28 March 2014  
Our Ref: 5565P.11DK

**Sandon Point (aka McCauley's Beach)  
Concept Plan and Project Approval Modification No. 4 (MP06\_0094 and MP07\_0032)  
Responses to submissions and Preferred Project Report - Updated**

**DFP PLANNING CONSULTANTS**

# ATTACHMENT I

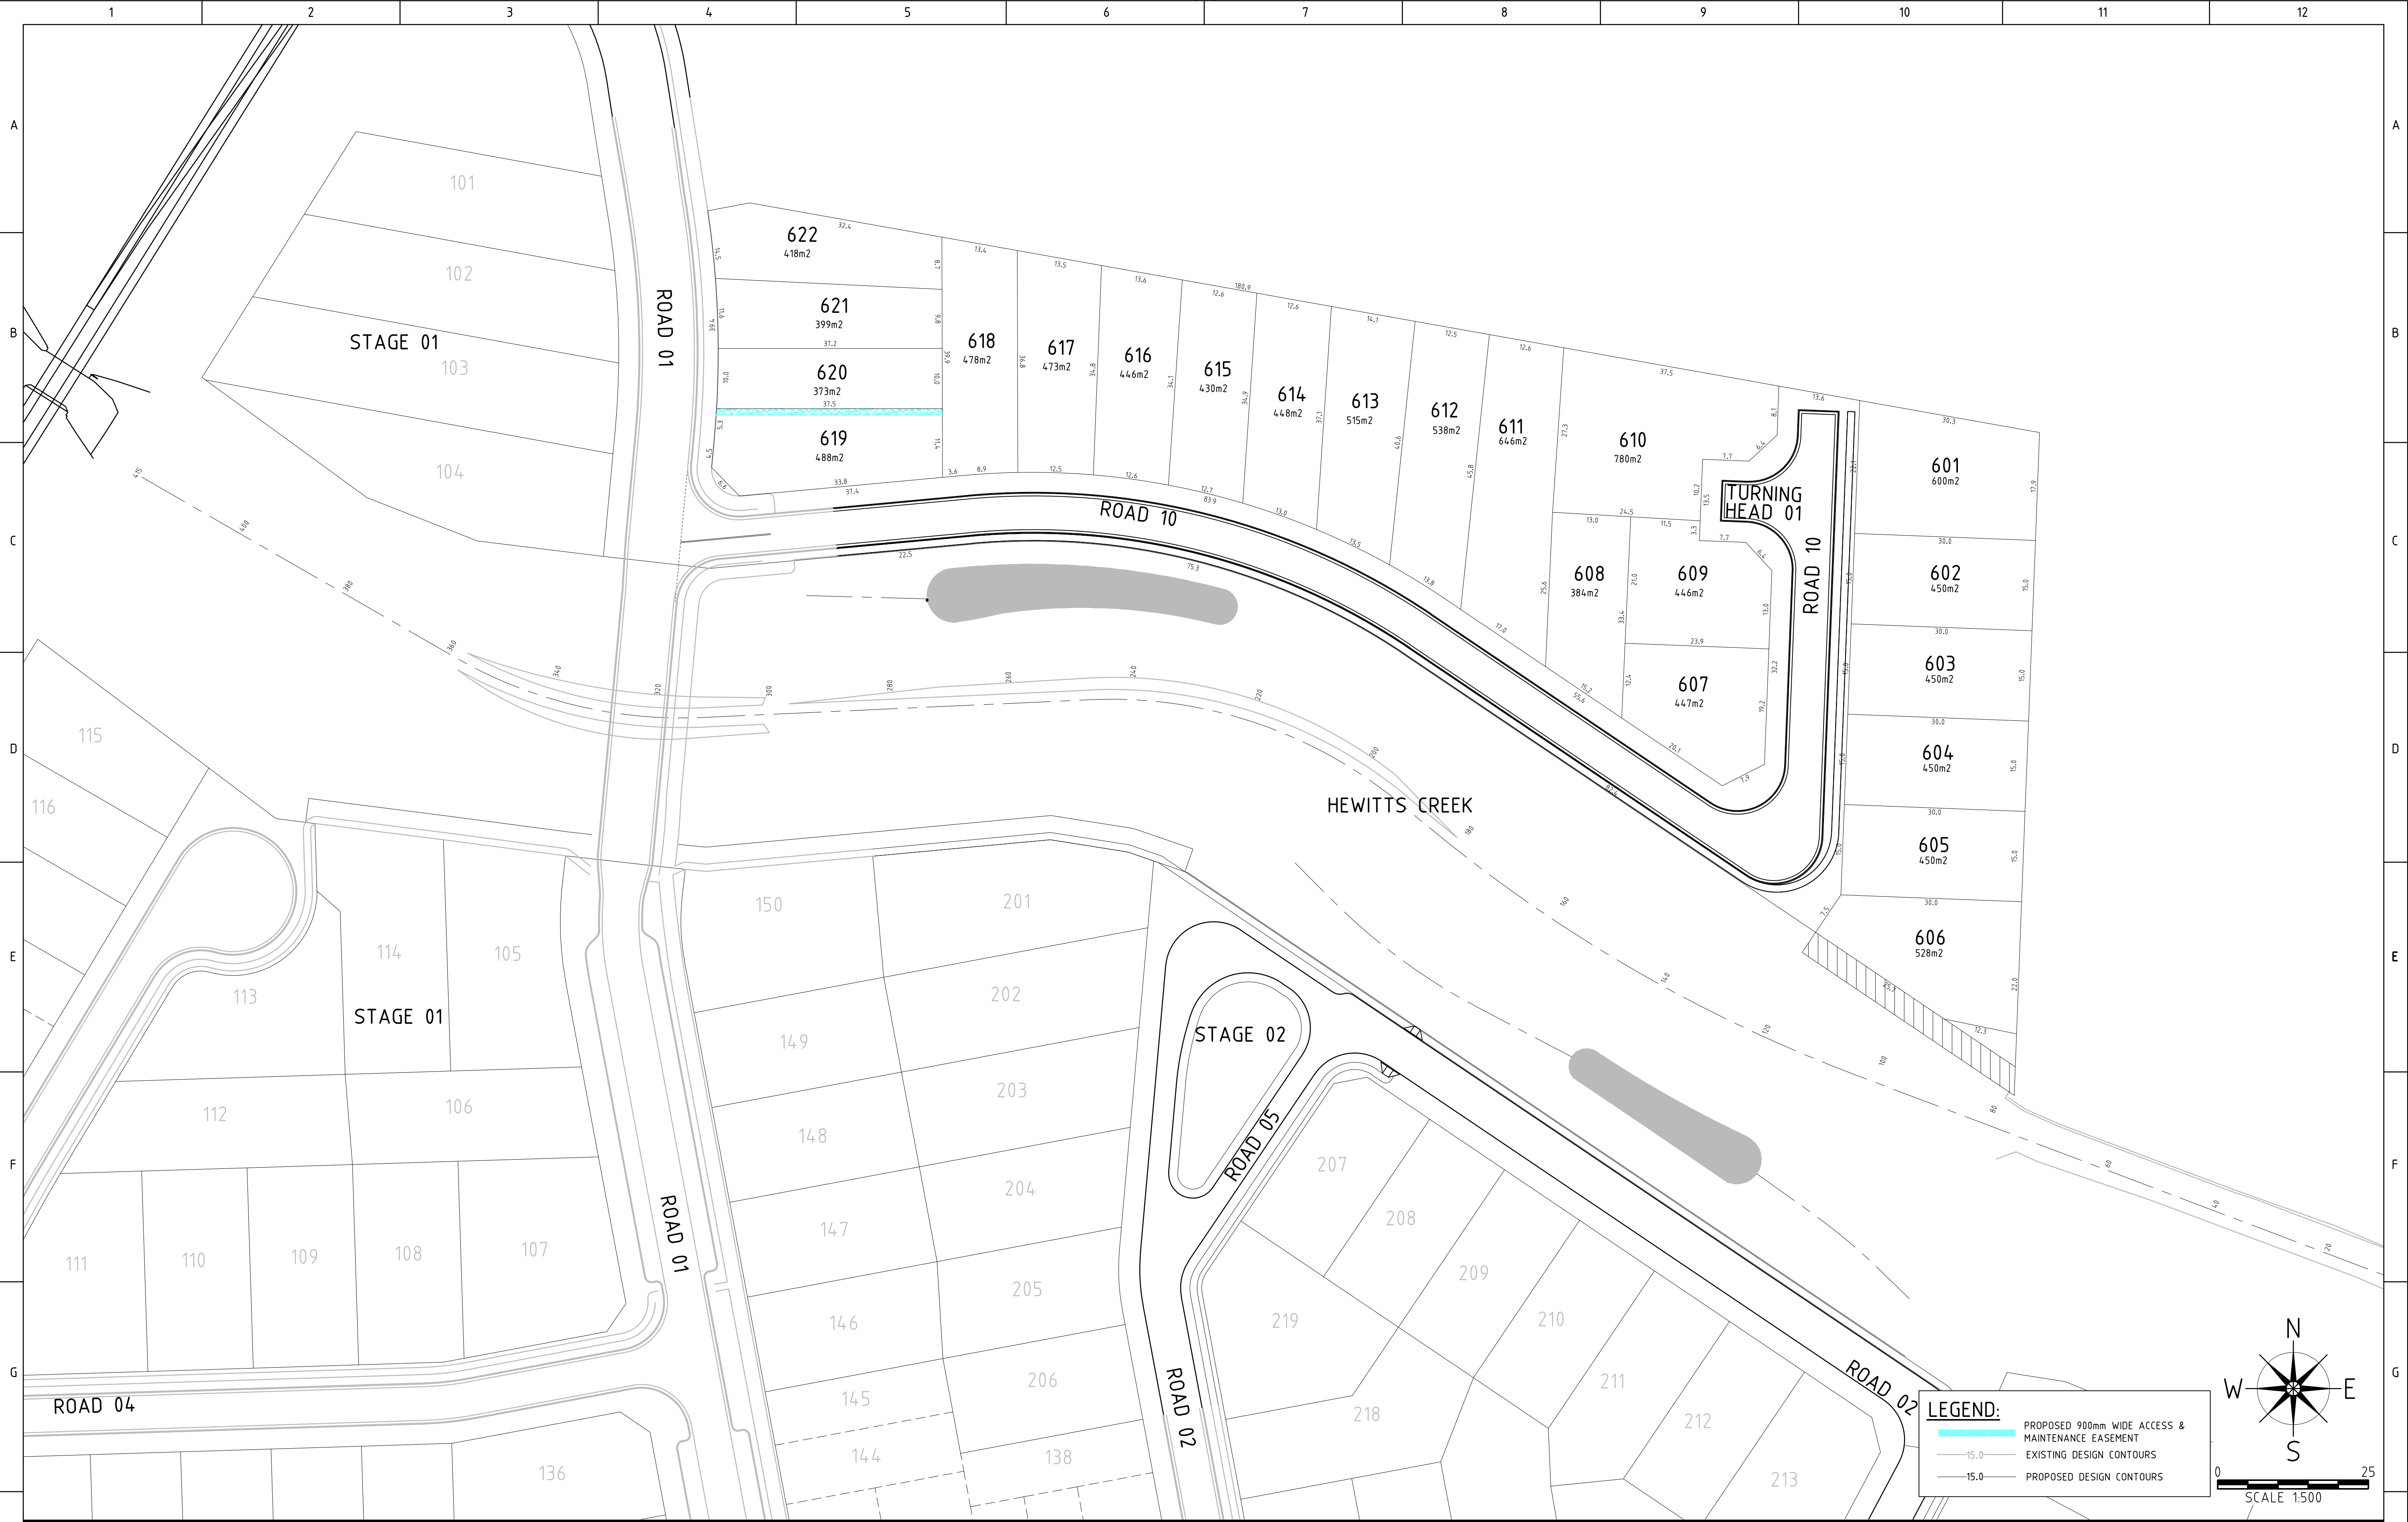
Arising from the review of the submissions it is proposed to make one minor change to the proposed modification. This is the inclusion of a zero lot line to proposed Lot 620 and the associated designation of an easement on proposed Lot 619 to allow for maintenance access. A copy of the amended plans is included at **Attachment 1**. The details of the s88B instrument will be provided with the subdivision certificate.

| REV |  |  |  |  | DATE     |  |  | BY  |  |  | APP. |  |  | DETAILS             |  |  | DRAWING STATUS              |  |  | SCALE:           |  |  | PROJECT TITLE                 |  |  | DRAWING TITLE    |  |  |
|-----|--|--|--|--|----------|--|--|-----|--|--|------|--|--|---------------------|--|--|-----------------------------|--|--|------------------|--|--|-------------------------------|--|--|------------------|--|--|
| P5  |  |  |  |  | 30/01/14 |  |  | MAH |  |  | KJM  |  |  | EASEMENT LINE ADDED |  |  | DESIGN BY JMA 28/05/12      |  |  | (on A1 Original) |  |  | STAGE 06                      |  |  | PROPOSED STAGE 6 |  |  |

- a) no change
- b) no change
- c) no change
- d) no change
- e) no change
- f) no change
- g) no change
- h) no change
- i) no change
- j) no change
- k) no change
- l) A restriction as to user on the title of proposed lots 607-622 as indicated on Drawing SK11 requiring future dwelling houses to comply with the following built form controls:
  - (i) A maximum floor space ratio of 0.5:1; and
  - (ii) A maximum height of building of 9mThe definitions of floor space ratio and height of building are as per SEPP (Major Development) 2005.
- j) A 900mm wide easement on the title of proposed lot 619 for access and maintenance to benefit proposed lot 620 to allow for a zero lot line along the southern boundary of proposed lot 620.
